Mobile Intel® Celeron® Processor on .13 Micron Process in Micro-FCPGA Package

Specification Update

October 2005

Document Number: [251309-028](#)

Figure 12. System Bus Reset and Configuration Timings

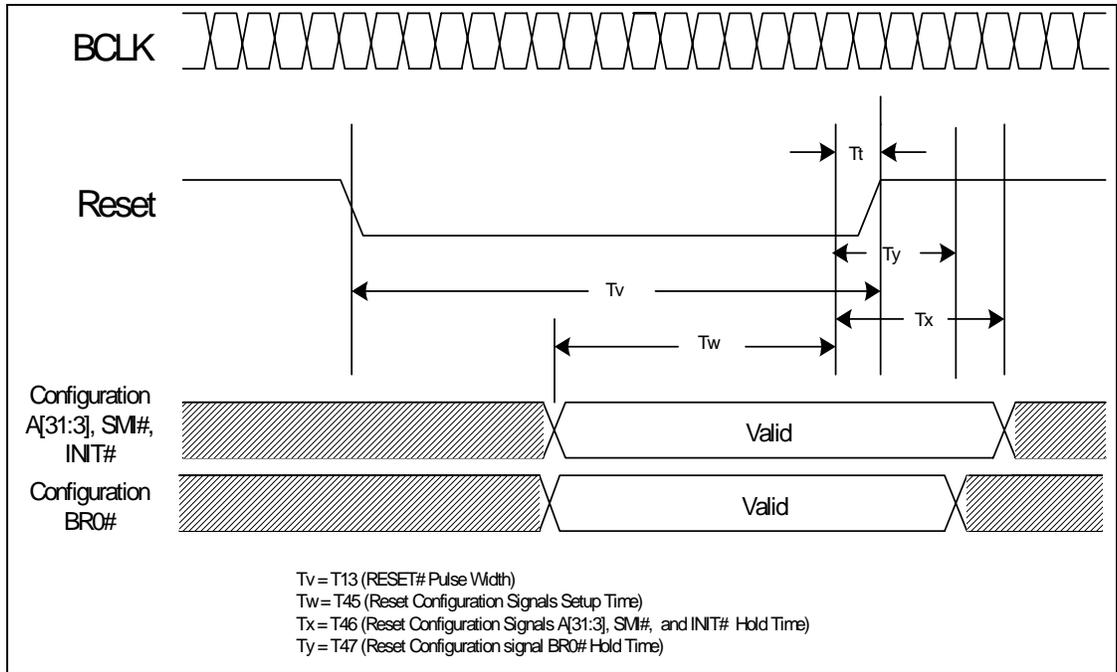
V2. BR0# Maximum Hold Time Specification Change

The BR0# maximum hold time has changed to 2 BCLKs. This change will be shown in the “System Bus AC Specifications (Reset Conditions)” table and “System Bus Reset and Configuration Timings” figure of the *Mobile Intel® Celeron® Processor on .13 Micron Process in Micro-FCPGA Package Datasheet*. This change will be incorporated in the next revision of the datasheet.

The following figure will be modified to reflect this change:

T# Parameter	Min	Max	Unit	Figure	Notes
T45: Reset Configuration Signals (A[31:3]#, BR0# INIT#, SMI#) Setup Time	4		BCLKs	13	1
T46: Reset Configuration Signals (A[31:3]#, INIT#, SMI#) Hold Time	2	20	BCLKs	13	2
T47: Reset Configuration Signal BR0# Hold Time	2	2	BCLKs	13	2

1. Before the deassertion of RESET#.
2. After clock that deasserts RESET#.
